MFN 09-459

Subject: Response to Portion of NRC RAI Letter No. 339 Related to ESBWR Design Certification Application – DCD Tier 2 Section 3.9 – Mechanical Systems and Components; RAI Numbers 3.9-215 S01 Parts A, B, C & D (revised) and 3.9-244 S01 (revised)

Enclosure 2

NRC RAI 3.9-215 S01

Figure C-1: Two sided fillet weld not welded all the way around.

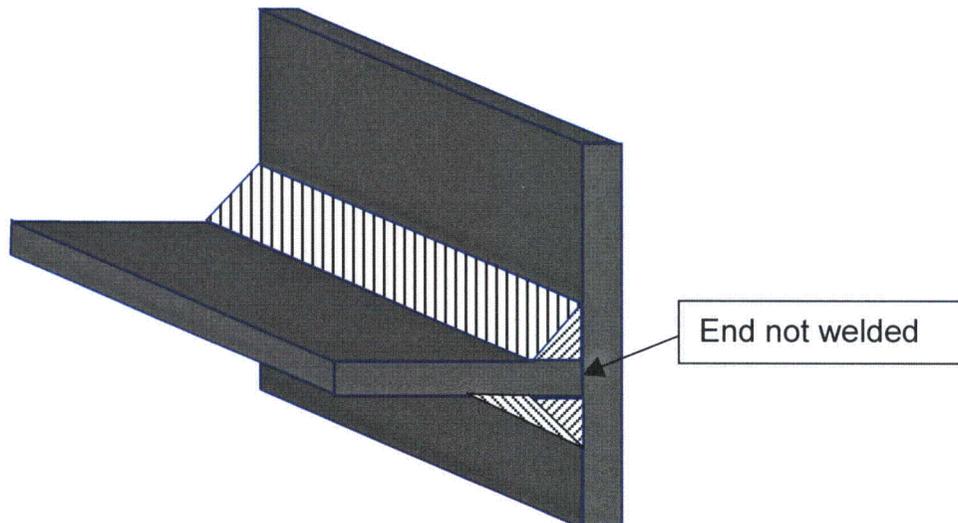
]]. GEH is requested to explain the meaning and significance of the terms "[[]]" What may be the recommended values of SCFs, if Approach (b) or (c) is used to obtain the [[]]?

Part C) The “ends of welds are not covered” refers to a two sided fillet weld where the weld is not wrapped around the ends, see figure C-1 below. The ends of the plate are not welded. [[
]].
